# ACCESS REPORT

Project: Block 9 Section 132, Casey ACT 2913  
Document Type: DA Assessment Report  
Our Reference: P2022\_3009-2 (DA) YW

This DA Assessment Report has been prepared by Amoeba Access at the request of the client, Jega and KG Capital, and relates to the proposed mixed use multiunit development located at Block 9, Section 132, Casey ACT 2912.

Figure 1 – Proposed continuous accessible pedestrian access route

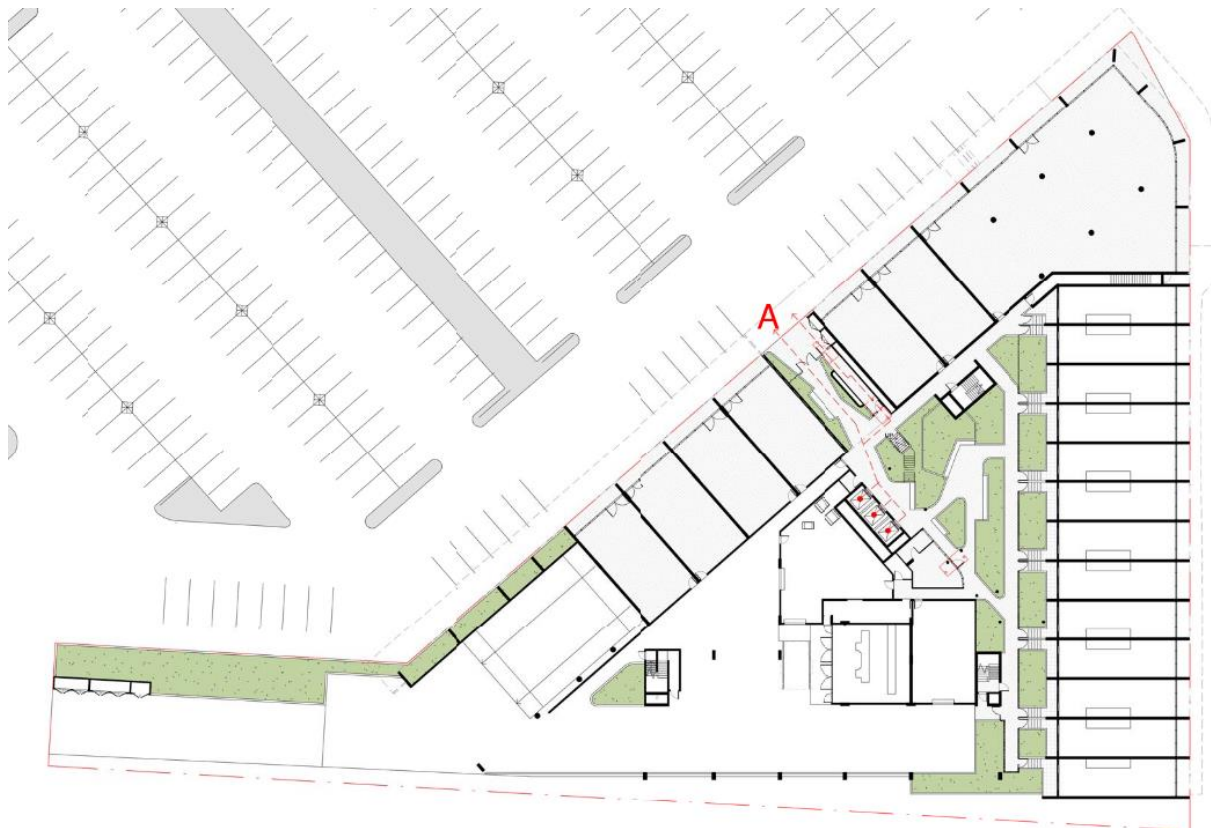
The main pedestrian entry point to the site is from the southwest boundary of the development site immediately adjoining Bentley Place, via the existing pedestrian path fronting the existing

parking and the commercial premises and connecting the upper ground level entry lobby A (as illustrated below).

At the current stage of the design development, it is unclear as to how the existing public council footpath merges with the new pedestrian entries of the development in regards to levels. Details are to be addressed as the development progresses to Building Approval stage noting that 1:20 gradient and crossfall of 1:40 shall be achieved.
